**Committee of Experts on the Transport of Dangerous Goods
and on the Globally Harmonized System of Classification
and Labelling of Chemicals****Sub-Committee of Experts on the Transport
of Dangerous Goods****Forty-ninth session**

**Issues relating to the Globally Harmonized System of
Classification and Labelling of Chemicals:
Classification criteria for flammable gases****Sub-Committee of Experts on the Globally Harmonized
System of Classification and Labelling of Chemicals****Thirty-first session**

**Joint work with the Sub-Committee of Experts on the
Transport of Dangerous Goods (TDG Sub-Committee)****Proposal for modification of the classification criteria and
hazard communication for flammable gases****Transmitted by the experts from Belgium and Japan on behalf of the
informal working group¹ on classification criteria for flammable gases**

Decision logic 2.2(†)

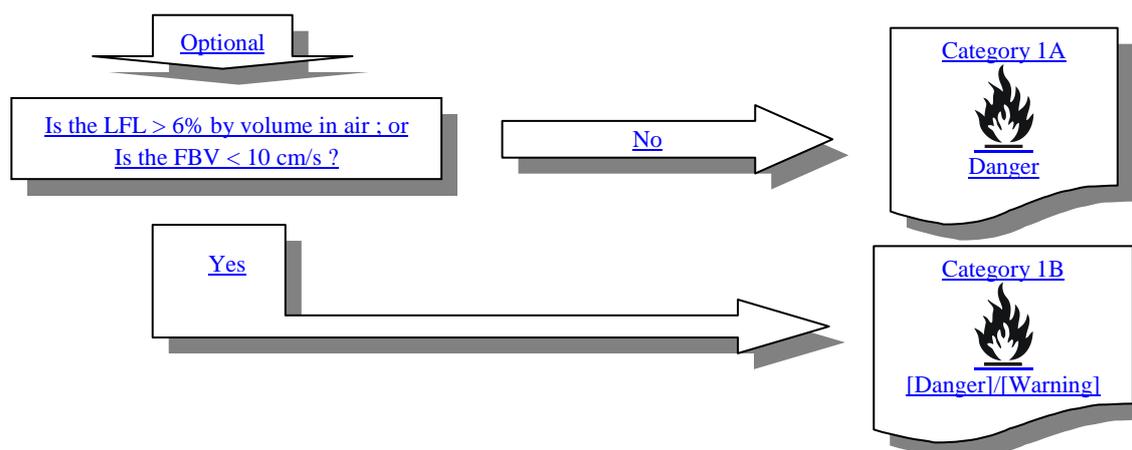
To classify a flammable gas, data on its flammability, on its ability to ignite in air and -on its chemical instability are required. In case of further categorisation within category 1, data on its lower flammability limit or its fundamental burning velocity is required. The classification is according to decision logic 2.2_-(a).
